# The potential application of the TfL Direct Vision Standard in UNECE regulation – The LDS and TfL position

Loughborough University Design School (LDS): Design Ergonomics Research Group  
Research Sponsored by Transport for London

## Our response to the ACEA VRU DVS proposal on the 16<sup>th</sup> of January 2020

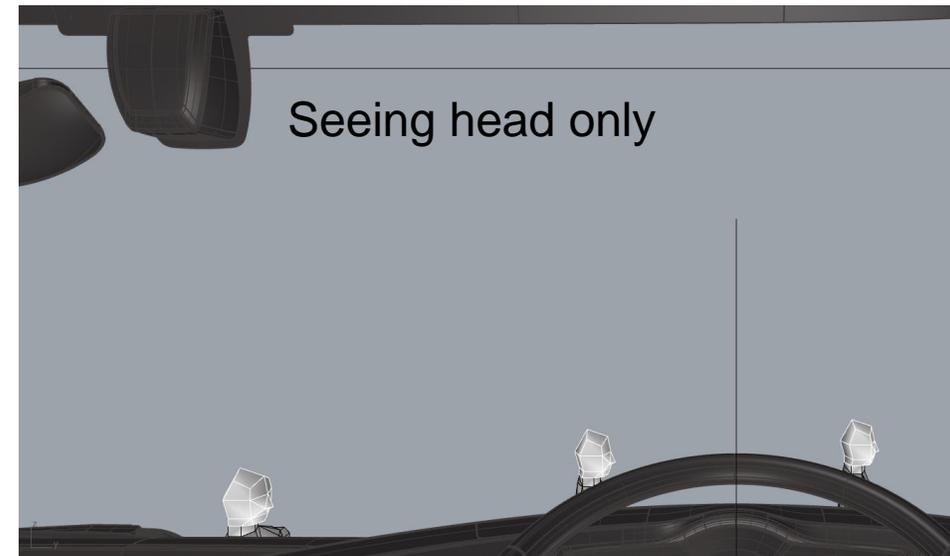
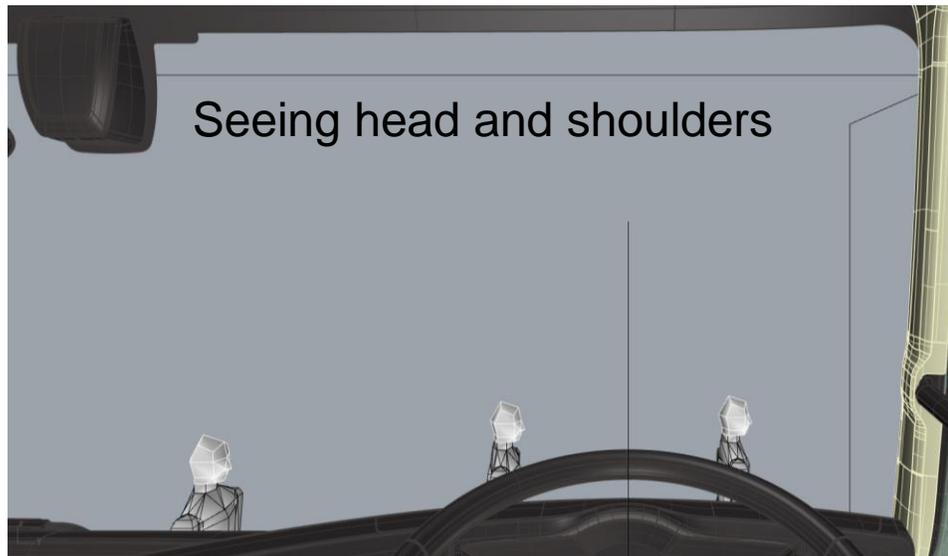
- Adopting a VRU simulation with a stature of 1600mm is not valid because it automatically excludes anyone shorter than this, which would be difficult to justify to the lay person i.e.

- 28% of UK female adults
  - 44% of French female adults
  - 38% of German female adults
  - 45% of Italian females adults
- Using an assessment method which only assesses performance at the edge of the mirror coverage area is poor in that it does not allow performance inside the “**area of greatest risk**” that is defined by the TfL project accident data analysis. This allows for improving performance over time

- The TfL approach defines a scale of performance in terms of star ratings that measure the ability to see the “**area of greatest risk**” and allows a progressive standard to be defined with improved performance limits over time, it is questionable that this is possible with the ACEA method

- It is not acceptable in our view to allow any part of the VRU simulation to be seen to allow detection. There is no scientific data available to support this assumption. The work of Richard Wilkie supports our definition of the requirement to see the head.
